Docket Item # 3
BAR CASE # 2009-0091

BAR Meeting
May 27, 2009

ISSUE: Demolition/Encapsulation
APPLICANT: Stephen Kulinski for Alabama Ave. LLC
LOCATION: 1105 Queen Street
ZONE: CL/Commercial

Figure 2. Floor plans depicting proposed demolition.

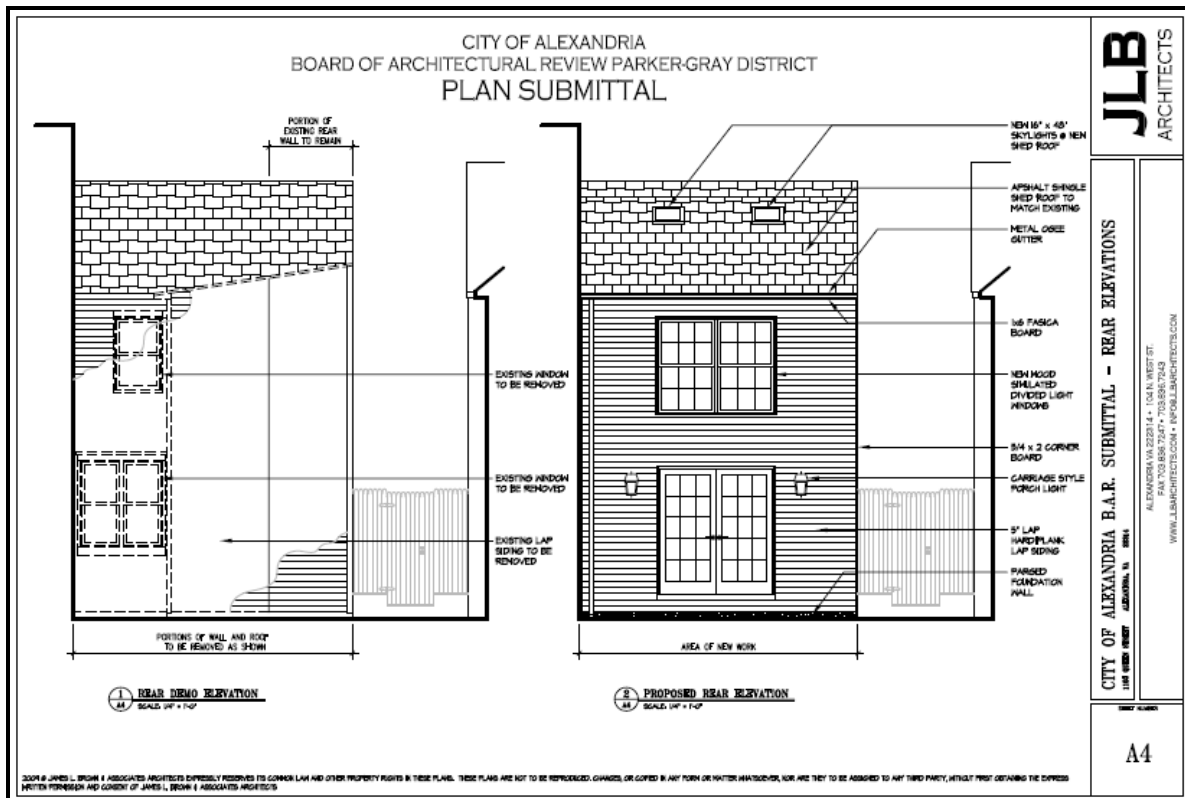
The applicant is requesting approval of a Permit to Demolish/Encapsulate in order to reconfigure an existing two-story rear ell at 1105 Queen Street. The applicant is proposing the demolition of the east wall of the rear ell and a portion of the north wall, to allow for expansion. The proposed expansion will be flush with the existing south wall of the house and extend the entire width of the existing house, encapsulating the north elevation of the main block. The demolition will constitute the loss of a wall containing a double window, two single windows, and a door on the first floor, and four single windows on the second floor. The design of the proposed construction would also require the encapsulation of approximately one hundred and fifty square feet of gable roof on the rear of the main block.
